Re: Case No. 16-0841-EL-BGA
Carroll County Energy LLC
Application for Second Amendment to its Certificate

In this Application for a Second Amendment to its Certificate, CCE is proposing to install a septic system on the facility property. The Ohio Environmental Protection Agency has issued a permit to install the septic system.

**Application for a Second Amendment of the
Carroll County Energy Certificate
Granted April 28, 2014 in
Case No. 13-1752-EL-BGN**

**Figure 02-2
Proposed Facility
and Vicinity**

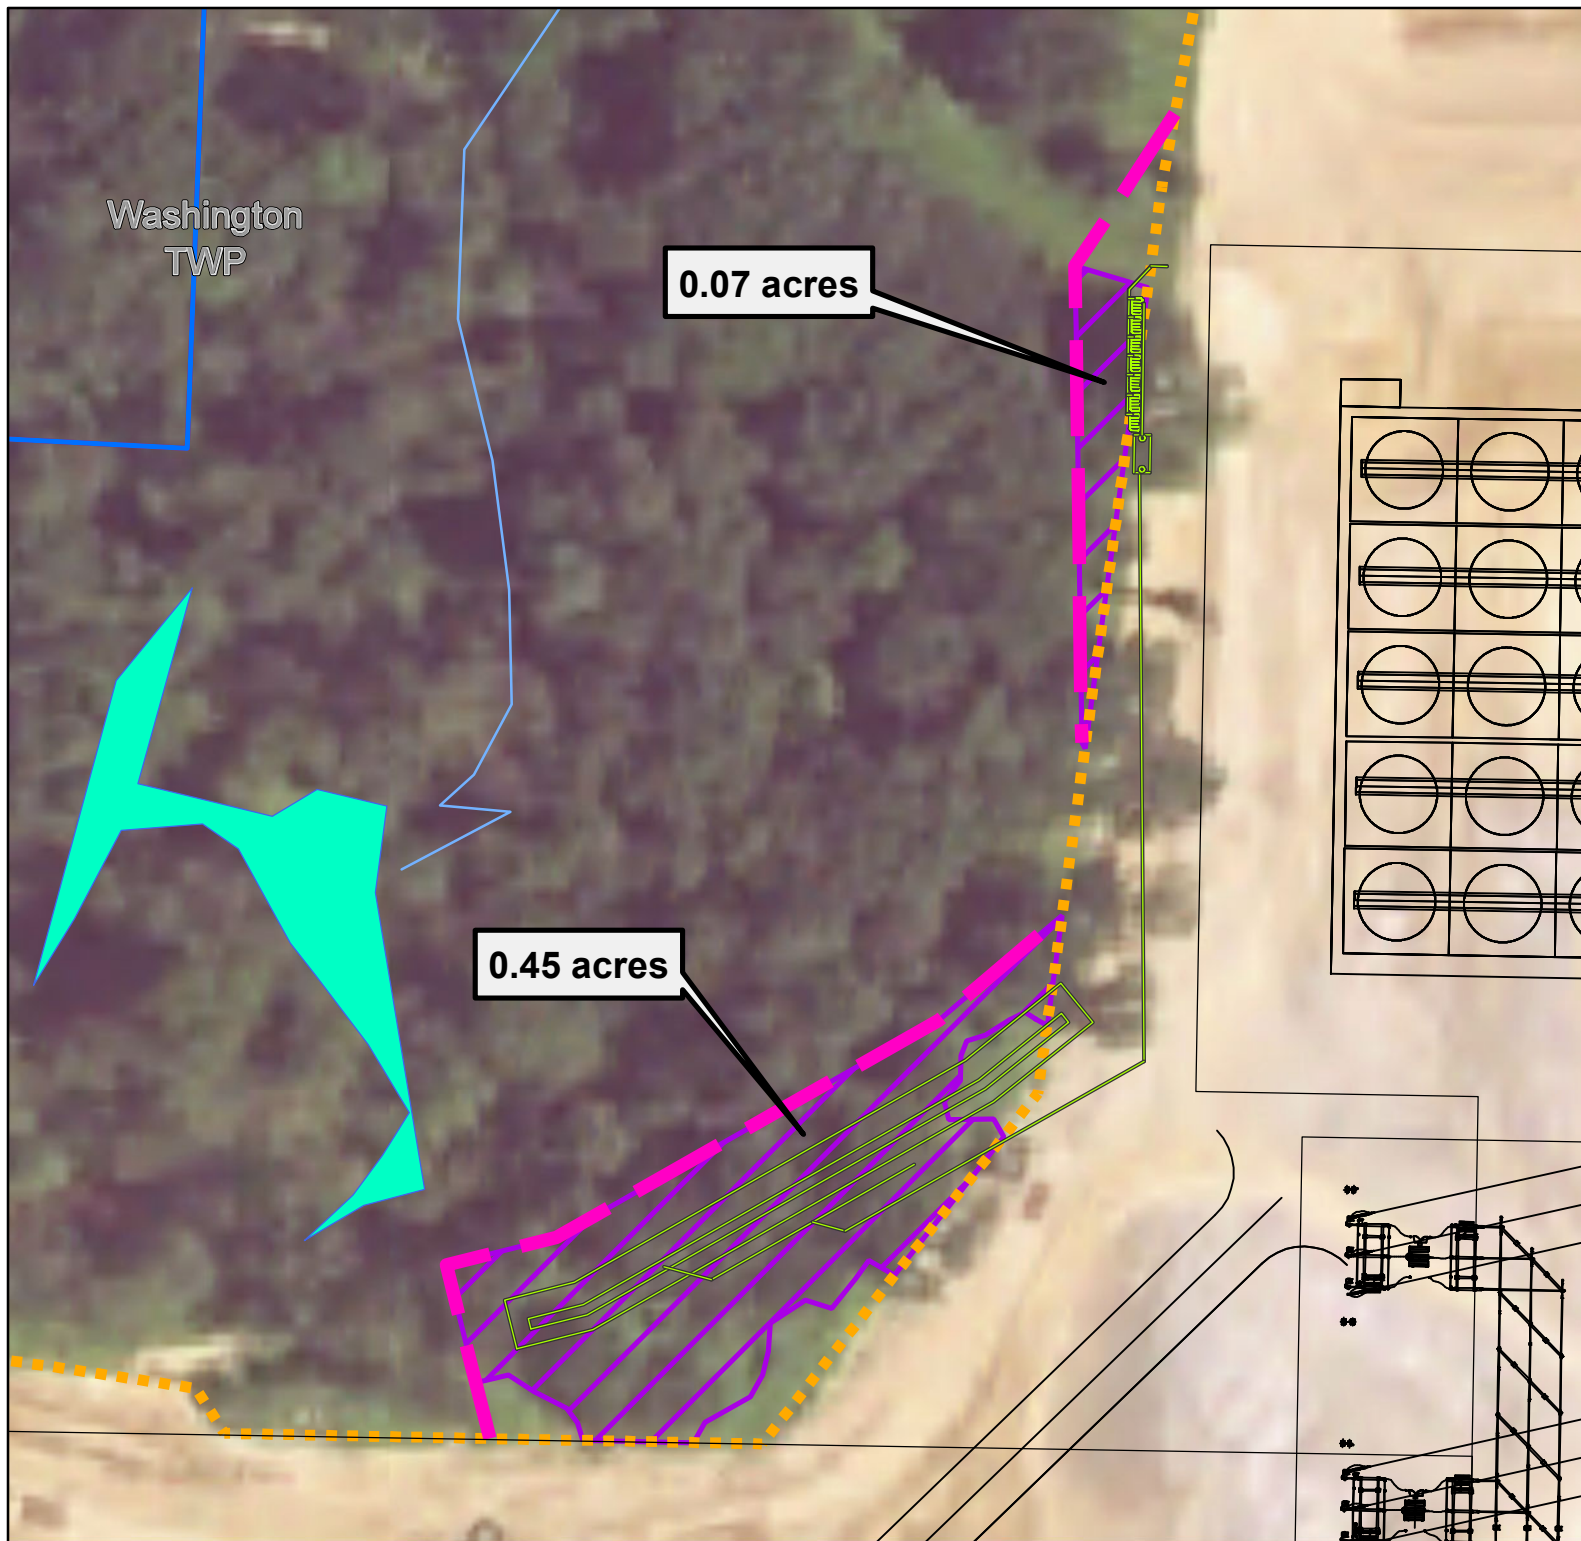
An updated Figure 02-2 shows the Facility and vicinity on an aerial photograph overlay, showing surrounding road names and major features of the proposed Facility. Additional detail is provided in Figures 02-3a through 3c, plot plans which depict the proposed septic system in relation to the Facility.

No additional land will be required for the proposed septic system. All septic system components will be located within the original Facility Site just outside of the Facility's existing limit of disturbance (see Figure 02-2).

An updated Figure 02-2 provides an aerial photograph showing the location of the Facility and proposed septic system in relation to surface features. As stated previously, the proposed septic system will be located entirely within the Facility Site, and just outside the prior limits of disturbance (as is required by Ohio EPA for installation of this type of system).

Figure 02-2b Proposed Additional Tree Clearing Areas

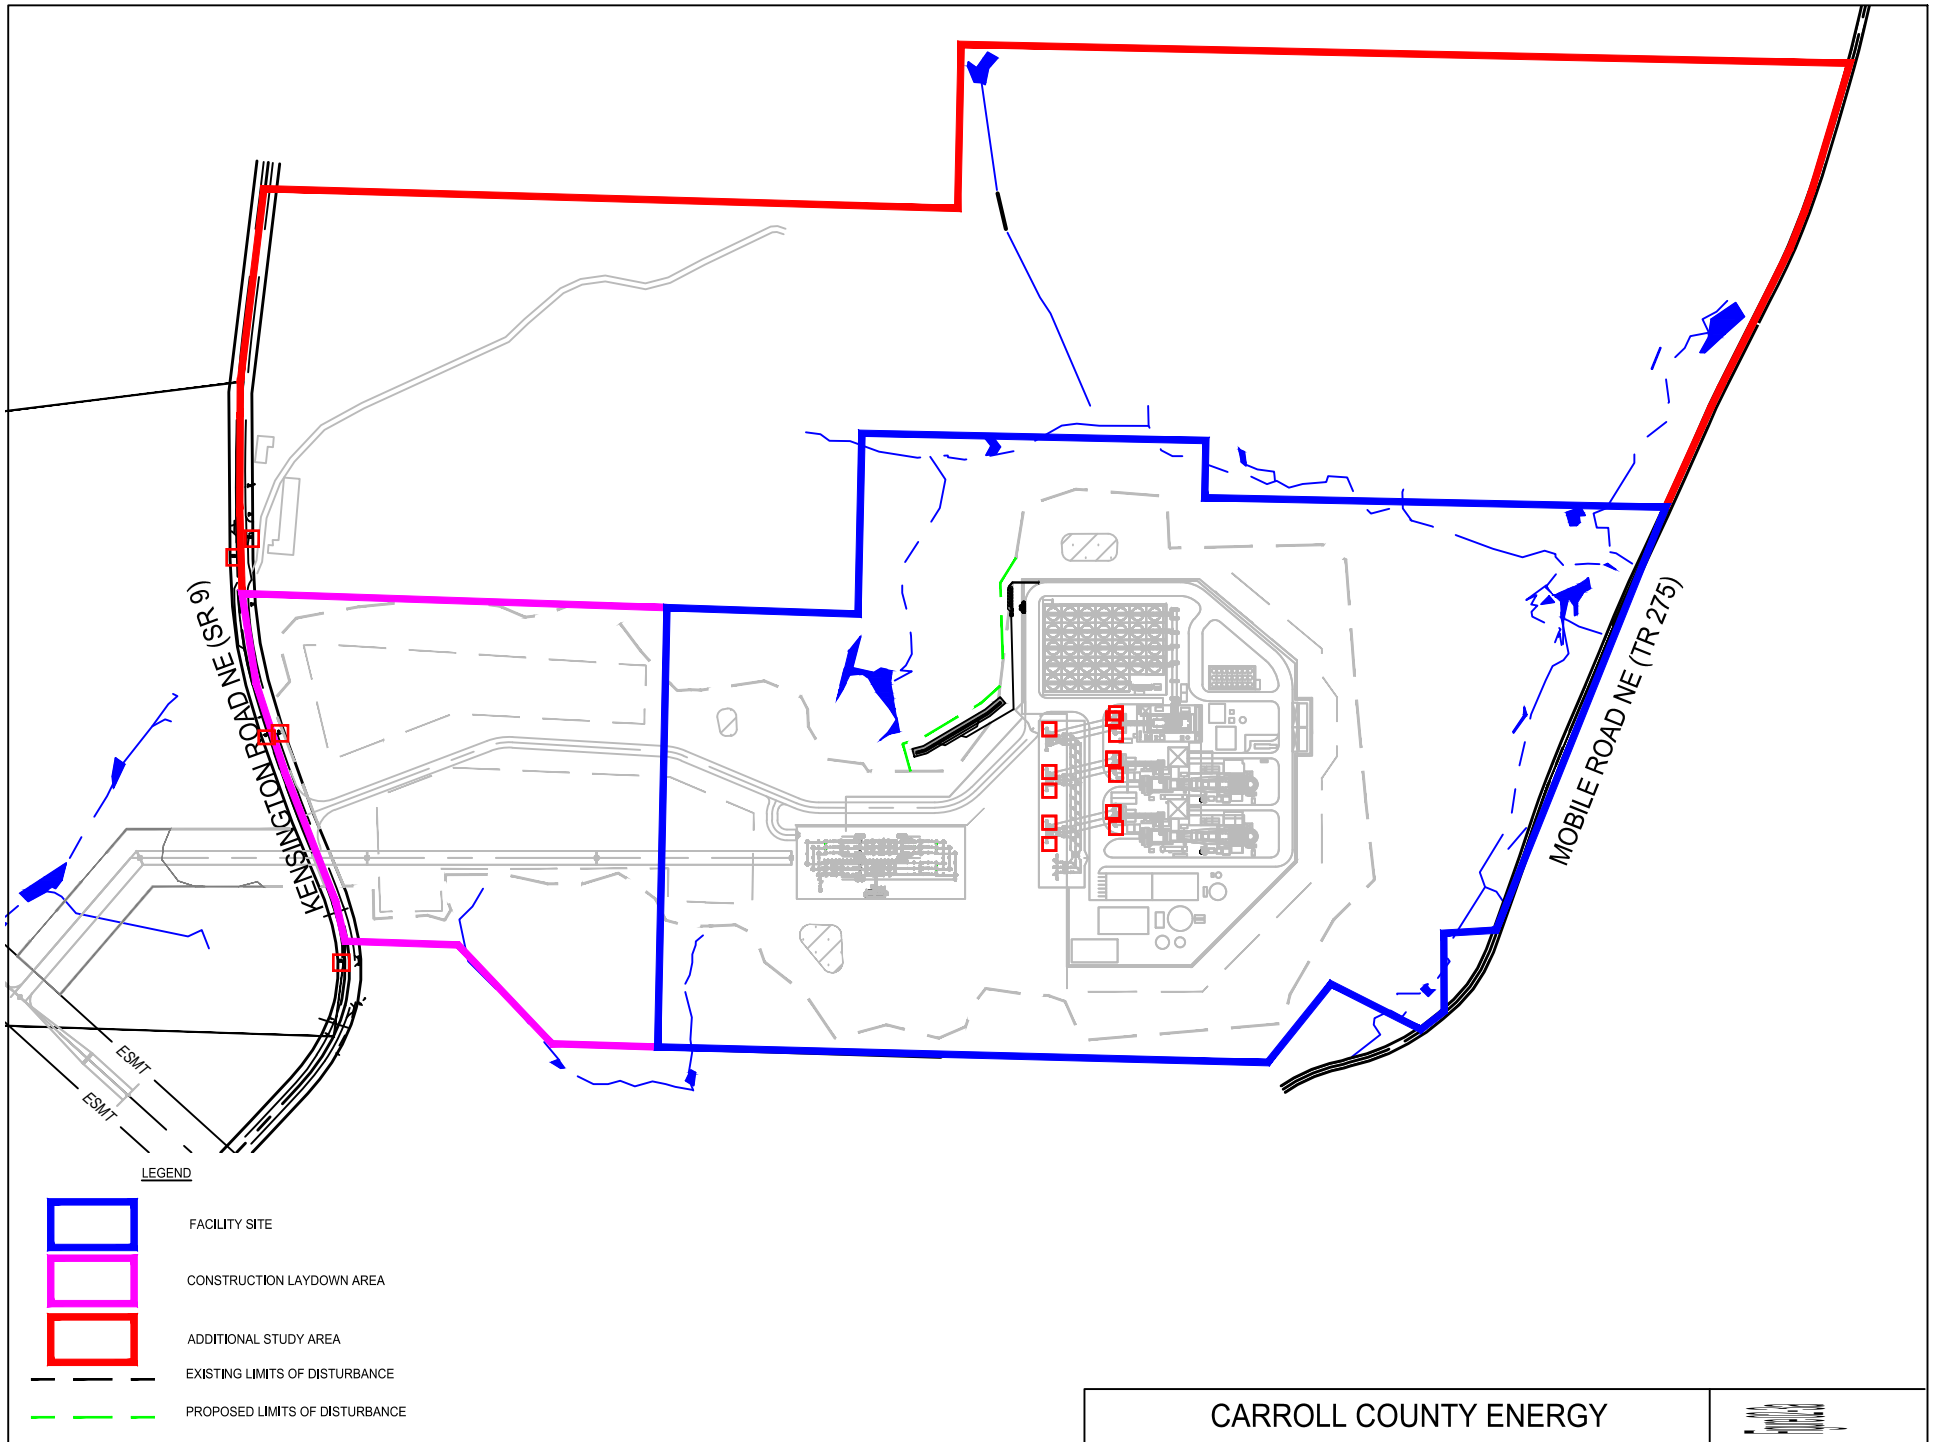
As previously described, the septic system will be installed within an approximately 0.65-acre area just north and west of the Facility. Approximately 0.53 acre of trees will be cleared from this area (see Figure 02-2b). Clearing will be restricted to occur between October 1 and March 31 to avoid impacts to potential summer bat roosting.

Installation of the proposed septic system will be within an additional 0.65 acre of land located adjacent and to the northwest of the original area of disturbance for the Facility. As shown in Figure 02-2b, approximately 0.53 acre of tree clearing will occur

No change since original filing; this proposed work area is within the original Facility Site. As previously discussed, the 0.53 acre of tree clearing associated with the installation of the proposed septic system will be limited to occur between October 1 and March 31 (see Figure 02-2b).
